NP-11-0024
June 16, 2011

Subject: Exelon Nuclear Texas Holdings, LLC
Victoria County Station Early Site Permit Application
Response to Request for Additional Information Letter No. 09
NRC Docket No. 52-042

Attached are responses to NRC staff questions included in Request for Additional Information (RAI) Letter No. 09, dated May 6, 2011, related to Early Site Permit Application (ESPA), Part 2, Sections 02.05.01 and 02.05.03. NRC RAI Letter No. 09 contained twenty-three (23) Questions. This submittal comprises a partial response to RAI Letter No. 09, and includes responses to the following six (6) Questions:

Figure 1b. Map of the VCS Site Area Illustrating Requested Information without Seismic Reflection Lines.

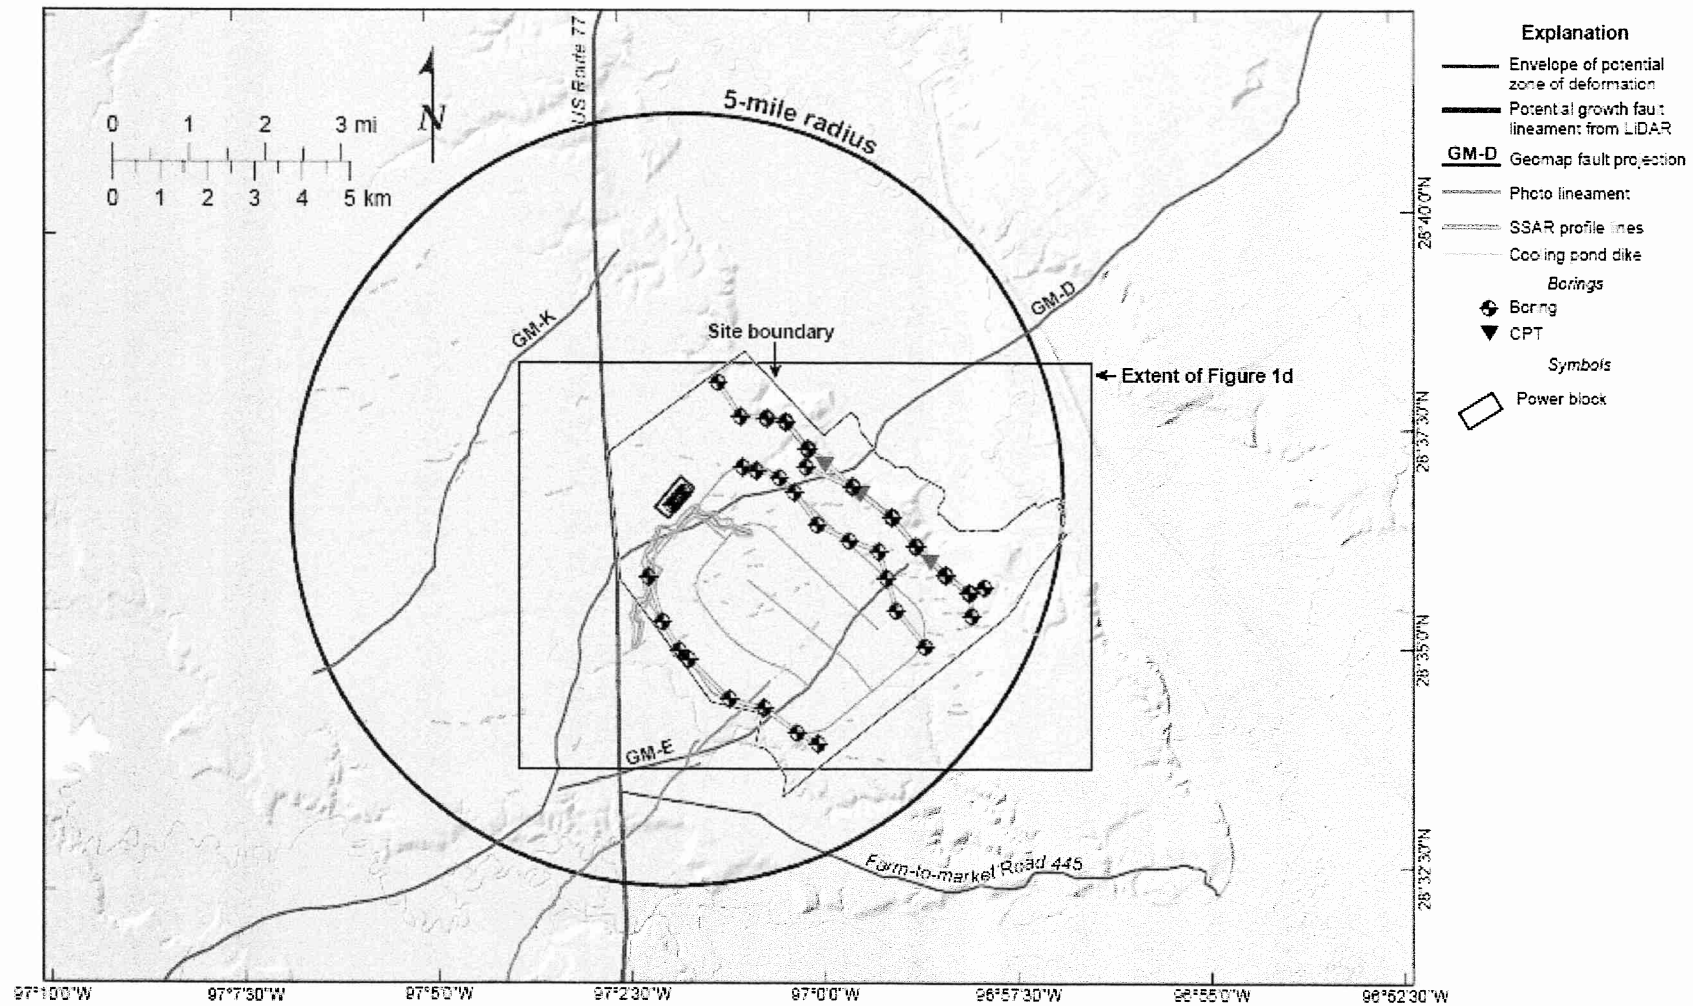
In SSAR Section 2.5.1, several figures illustrate various data sets (seismic reflection, GeoMap, aerial photography, and LiDAR) that lead to your interpretations about the growth faults in the VCNPP vicinity. In order to understand the link between these data and the subsequent interpretations of growth fault structures, and in accordance with 10 CFR 100.23 (d)(2), please provide:

- a) A plan-view figure with a scale similar to Figure 2.5.1-41 (i.e., extending a little beyond the 5-mile radius) that contains the following information:

- plant boundary, power block outline, outline of the cooling water basin, and the locations of US Route 77 and McFaddin Rd.
 - locations of geotechnical boreholes and cross-section lines from Figures 2.5.1-34 and -35 and 2.5.4-14, -15, -16.

- LiDAR traces for faults D and E and the interpreted zones of deformation bounding these faults.
 - LiDAR hillshade base map
 - aerial photo lineaments

- GeoMap locations of faults D, E and K as projected to the surface.
 - location of the seismic reflection lines and the point locations where faults D, E and K fall on those lines.

- electronic version of this figure that can be magnified to examine the details.
- b) A figure that contains a subset of the previous request that includes the LiDAR lineaments from Figure 2.5.1-42, the air photo lineaments from Figure 2.5.1-37 and the GeoMap fault traces from Figure 2.5.1-40 on the LiDAR base map.

- Figure 1a – The figure requested as described in part (a) of this RAI question. There is no “zone of deformation” mapped for the lineament associated with growth fault E. Such a zone was not defined as part of the VCS ESP because of the considerable distance between the lineament and the safety related systems, structures, and components that are within the power block area. The points where faults GM-D and GM-K “fall on” the seismic reflection lines are shown for lines GDI, GSI, and TGS. These points are the surface location of the up-dip extent of the faults as identified in the seismic reflection data (see SSAR Figures 2.5.1-45 to 2.5.1-48 and SSAR Table 2.5.1-4). The location of GM-E is not shown on GDI, GSI and TGS because, as stated in SSAR Section 2.5.1.2.4.2.3.1.3, GM-E is not observed in the seismic reflection data. Also note that McFaddin Rd. is labeled as “Farm-to-market Road 445” in the figure consistent with the

labels used in the VCS SSAR (see SSAR Figure 2.5.1-39). The seismic reflection profile locations are proprietary data that cannot be publicly released, so this figure is not for public release.

- Figure 1b – This figure is a publicly releasable version of Figure 1a. Figure 1b is the same as Figure 1a, but without the proprietary seismic reflection profile locations presented in Figure 1a.
- Figure 1c – A version of Figure 1a with a smaller extent (i.e., larger scale) so that the details of the cross-section lines and borehole labels can be easily seen. The seismic reflection profile locations are proprietary data that cannot be publicly released, so this figure is not for public release.
- Figure 1d – This figure is a larger-scale version of Figure 1b that allows the details of the cross-section lines and borehole labels to be easily seen. Figure 1d is for public release and does not show the location of proprietary seismic reflection profile locations presented in Figure 1c.
- Figure 2 – The figure requested as described in part (b) of this RAI question.

Figure 1. Color Shaded Relief Map with the NRC LIDAR Lineaments.

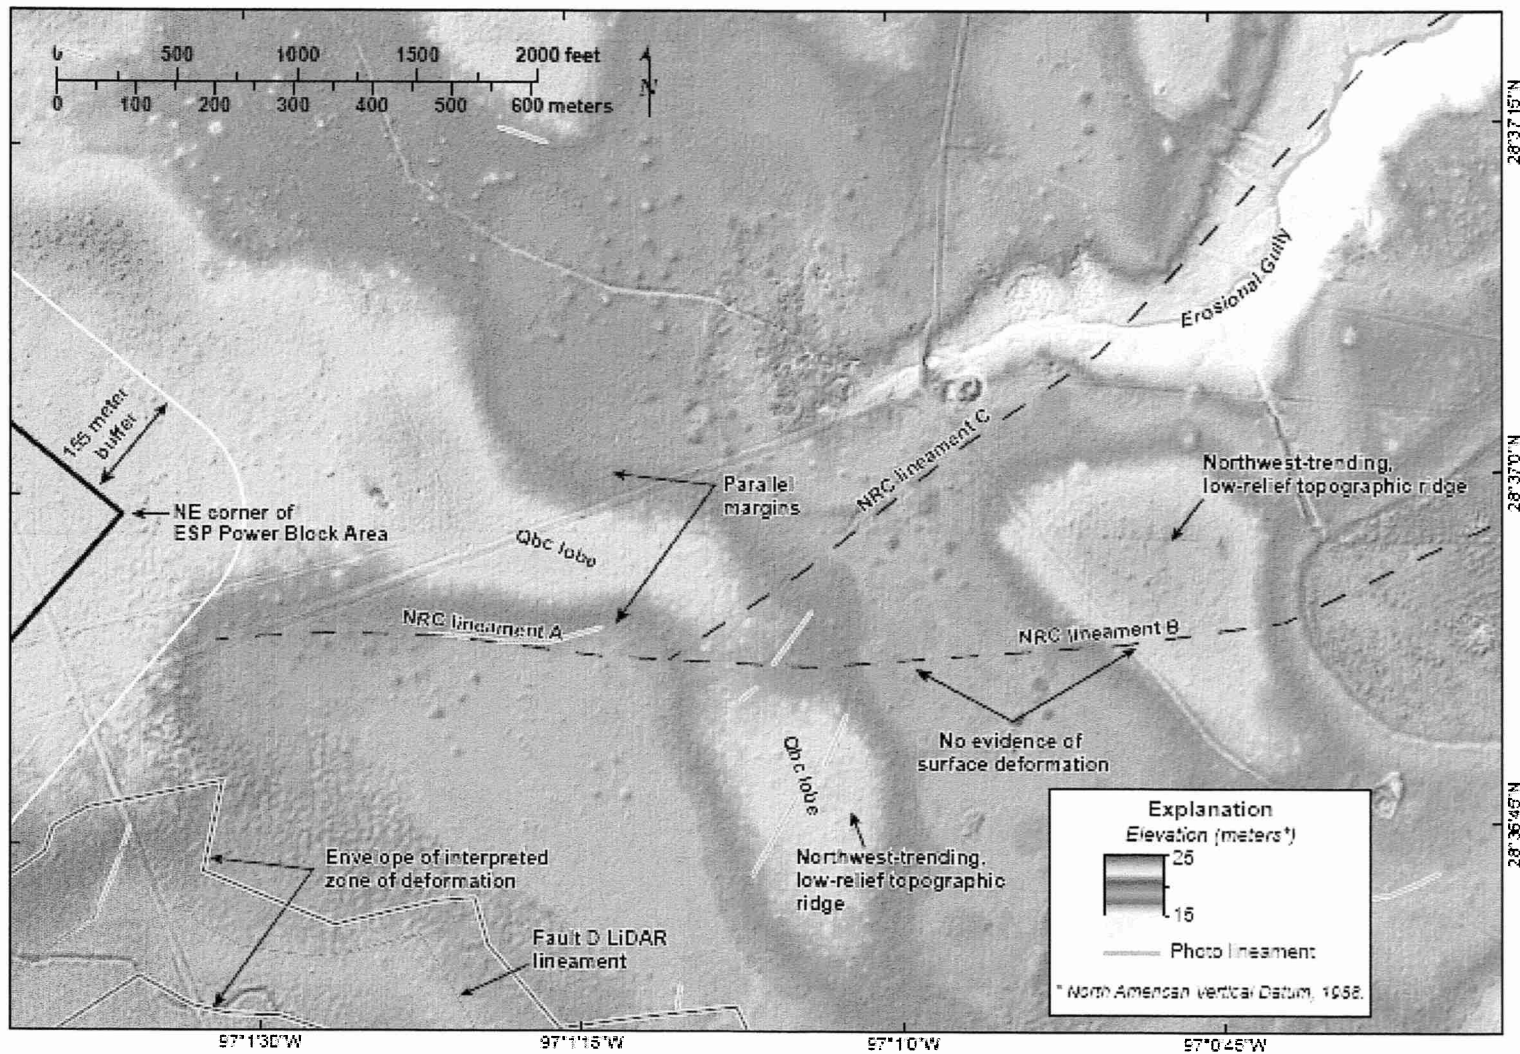
In SSAR Section 2.5.1.2.4.2.3 you describe the identification of growth faults from aerial photographs and LiDAR topography shaded-relief maps. The staff observes that both air-photo and LiDAR data (Fig. 2.5.1-37, -38, -42) suggest that growth fault D (or a splay thereof) may extend 1-2 km northeastward instead of turning sharply to the southeast near the power block (**see attached Figure 1**). This may be a more linear trace for Growth fault D that would correspond to the more typical trend of other GeoMap faults in the vicinity. In addition, cross-sections in Figure 2.5.4-15, between boreholes B-04 and B-2316 and Figure 2.5.4-16, between boreholes B-2354 and B-2322, show small (~1 m) steps in topography and 1-3 m apparent offsets of several subsurface units that may be evidence of a fault trending in this direction.

In accordance with 10 CFR 100.23 (d), explain why this potential trend was not considered part of fault D. Please provide an evaluation of the borehole data, cited above, with regard to a possible shallow fault trending northeast rather than southeast. Please discuss the safety implications of this possible fault splay, which would be closer to the power block.

This RAI question included a figure (titled “*USGS RAI 2.5.1-Figure 1*” and referred to here as NRC Figure 1) that shows NRC-proposed alternative traces of the lineament associated with growth fault D. These alternative traces are shown in NRC Figure 1 as two dashed lines trending west from the edge of the Guadalupe River flood plain and merging into one line at approximately the VCS site 0.6-mile radius. The RAI question did not provide the coordinates of the alternative lineaments, so an interpretation of the NRC-proposed alternative lineaments in NRC Figure 1 is presented in Figures 1 and 2 of this RAI response. For ease of discussion, the three components of the NRC-interpreted lineaments are referred to as NRC lineaments A, B, and C (Figure 1). Assumptions have been made in this RAI response regarding the geomorphology along the NRC proposed lineaments and the criteria used by the NRC to map these lineaments. Based on these assumptions, the RAI response systematically evaluates the data available for inferring the NRC proposed lineaments.

Based on the location of the NRC-proposed lineaments as presented in Figure 1, the geomorphology along these proposed lineaments can be described as follows.

NRC lineament A is the westernmost of the NRC-identified lineaments (labeled “Prominent LiDAR lineament” on NRC Figure 1) and is mapped along the base of an approximately east-west-trending topographic break.

NRC lineament B appears in NRC Figure 1 as an eastward extension of NRC lineament A (labeled “LiDAR lineament (modified by pond construction?)” in NRC Figure 1). NRC lineament B bisects two northwest-trending low-relief ridges and a circular depression (Figure 1). At its easternmost extent, NRC lineament B is coincident with a west-southwest-trending erosional gulley (Figure 2).

NRC lineament C appears in NRC Figure 1 as an east-northeast extension of NRC lineament A (labeled “Alternative trace or splay of fault D” in NRC Figure 1). The majority of NRC lineament C is mapped in the center of a northeast-striking erosional gulley and the easternmost extension of the splay is coincident with a low-relief south-facing topographic break on the Guadalupe River flood plain (Figures 1 and 2).

Using these criteria, and the geologic maps developed as part of the VCS ESP project site (SSAR Figure 2.5.1-5), the NRC-proposed lineaments can be evaluated to determine whether they are potentially related to growth faults or probably related to fluvial process. NRC lineament A is mapped along the base of a 1,600-ft-long (500-m-long) south-facing east-west-trending topographic break. This topographic break was identified on aerial photography (SSAR Figure 2.5.1-37). However, upon more detailed inspection of the LiDAR data during construction of the site geologic map, it was determined that this topographic break is the margin of a subunit within the Beaumont Formation (Unit Qbc). As discussed in SSAR Subsection 2.5.1.2.4, Unit Qbc consists of levee and flood plain deposits that form locally raised topography consisting of silt, clay and minor amounts of sand and gravel. This particular Qbc deposit forms a northwest-striking lobe (i.e., raised deposit) with generally parallel boundaries (Figure 1 and SSAR Figure 2.5.1-5). As shown in Figure 1, the northern north-facing margin of the Qbc lobe is parallel to NRC lineament A, and, at the east end of NRC lineament A, both margins of the Qbc lobe make parallel turns south-southeast across NRC lineaments B and C. These parallel margins of the lobe support the conclusion that the raised deposit is not related to surface deformation from growth faulting. In addition, there are no topographic breaks or steps crossing the Qbc lobe coincident with any of the NRC-proposed lineaments (Figure 1) further supporting the conclusion that the NRC-proposed lineaments do not have any post-Beaumont deformation observable within the Qbc lobe. Therefore, it does not appear that NRC proposed lineament A is related to surface deformation associated with growth fault D.

Similarly, the available geomorphic observations along NRC-proposed lineaments B and C do not support the interpretation that these lineaments represent a possible northeast extension of growth fault D (Figures 1 and 2). These NRC-proposed lineaments do not meet the criteria used as part of the VCS ESP to identify potential growth fault lineaments (see SSAR Subsection 2.5.1.2.4.2.2). For example:

Figure 1. Map of Shale Diapirs and Ridges within the VCS Site Vicinity.

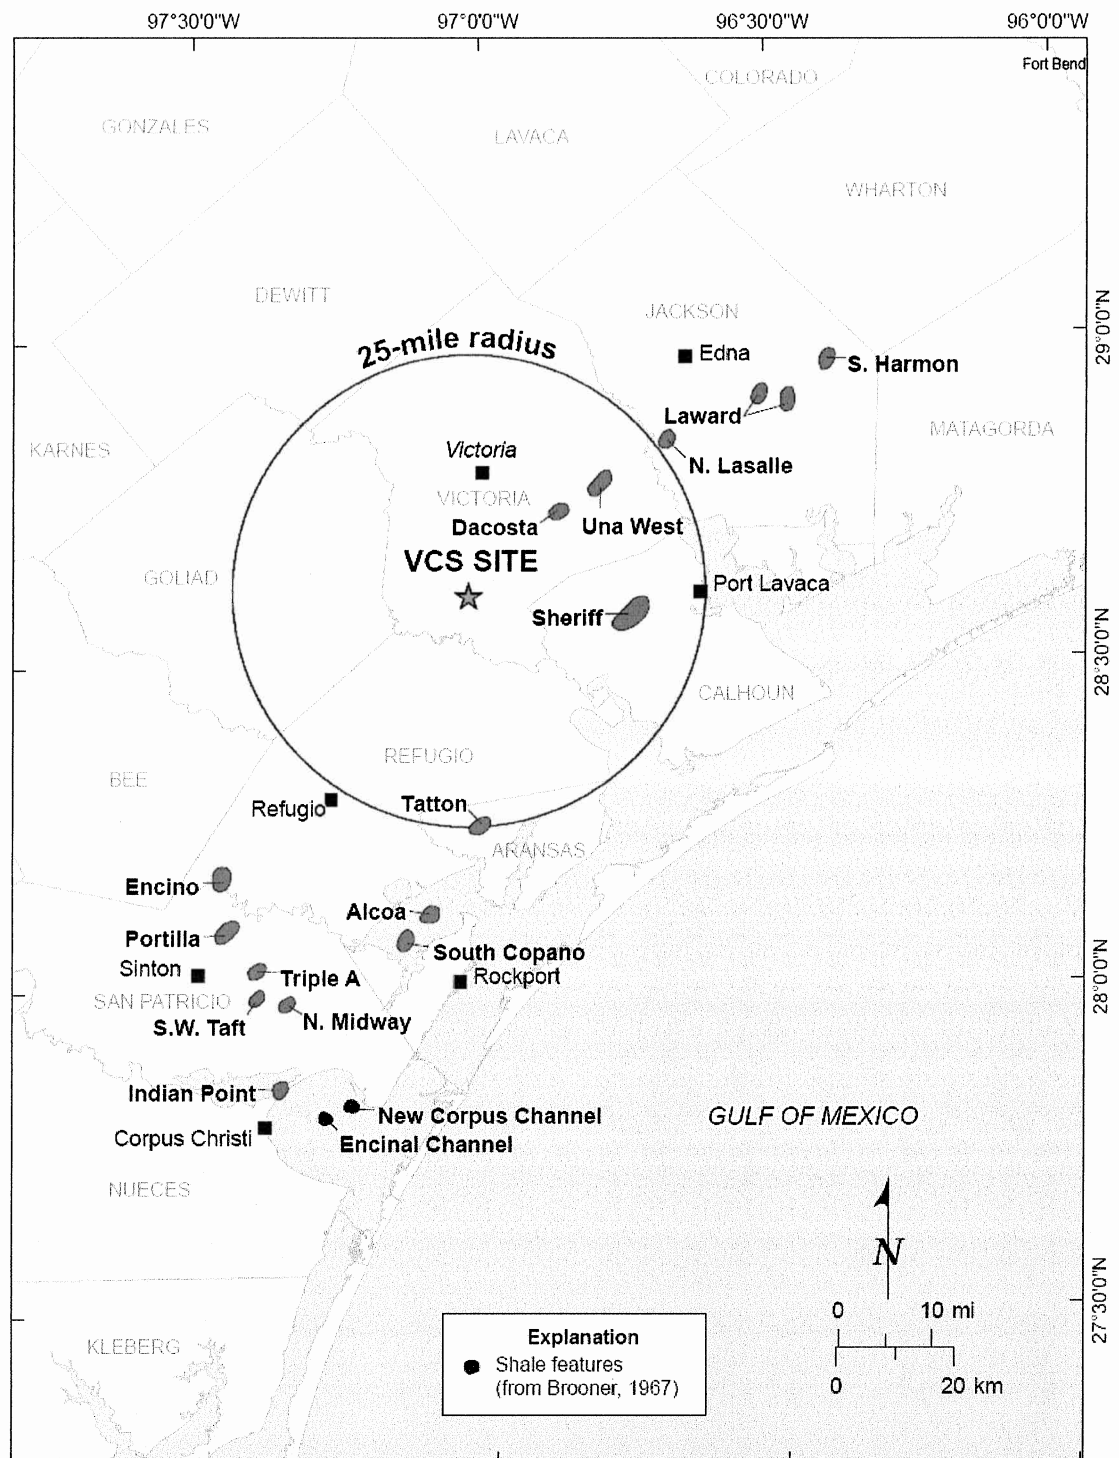
In SSAR section 2.5.1.2.4.2 you stated that the Vicksburg growth faults most proximal to the site overlay the San Marcos Arch, a region with relatively little salt, so many of the growth faults in this area are associated with shale ridges, massifs, or diapirs. In support of 10 CFR 100.23 (d), please discuss the evidence for these shale features associated with the Vicksburg faults in the VCS vicinity and illustrate the location of any shale ridges, massifs or diapirs present in the VCS vicinity.

As summarized in SSAR Section 2.5.1.2.4.2, many of the Vicksburg growth faults most proximal to the VCS site are associated with shale features such as shale ridges, massifs, or diapirs. The association between the Vicksburg growth faults and shale features has been established through industry-standard investigation practices (e.g., analysis of seismic reflection lines and borehole data) and has been reported in numerous peer-reviewed scientific articles (e.g., Bruce, 1973; Combes, 1993; Culotta, et al., 1992; Diegel, et al., 1995; Erxleben and Carnahan, 1983). In general, these studies report that Vicksburg growth faults sole into either: (1) the upper sections of the Jackson or Vicksburg shales, or (2) within the deeper Clairborne and Midway Group shales of the Paleocene and Eocene section (Bruce, 1973; Combes, 1993; Culotta, et al., 1992; Diegel, et al., 1995; Erxleben and Carnahan, 1983). For example, Culotta et al. (1992) interpret a 155-mi-long (250-km-long) seismic survey across the San Marcos Arch parallel to the western edge of Jackson County (the county to the east of Victoria County) and identify Vicksburg growth faults soling into a shale diapir within the Jackson and Clairborne Formations at the southern most portion of the seismic line. Similarly, Combes (1993) presents seismic lines in Goliad and Refugio counties (to the west of Victoria County) imaging Vicksburg growth faults that sole into shale features.

The only publicly available regional compilation of shale features within the VCS site vicinity identified during the ESP project is shown in Figure 1. This figure shows the location of 18 shale features that are between approximately 12 and 58 mi (19 to 93 km) from the VCS site (Bishop, 1977; Brooner, 1967). Of these 18 diapirs and ridges, only three diapirs (Dacosta, Una West, and Tatton) and one ridge (Sherriff) are mapped within the VCS site vicinity. These shale features are all cored by Jackson-Vicksburg shale and are mapped within the lower to middle Frio Formation (Bishop, 1977). In general, these shale features are on the order of one square mile (2.4 to 2.8 square kilometers) or less in area (Brooner, 1967).
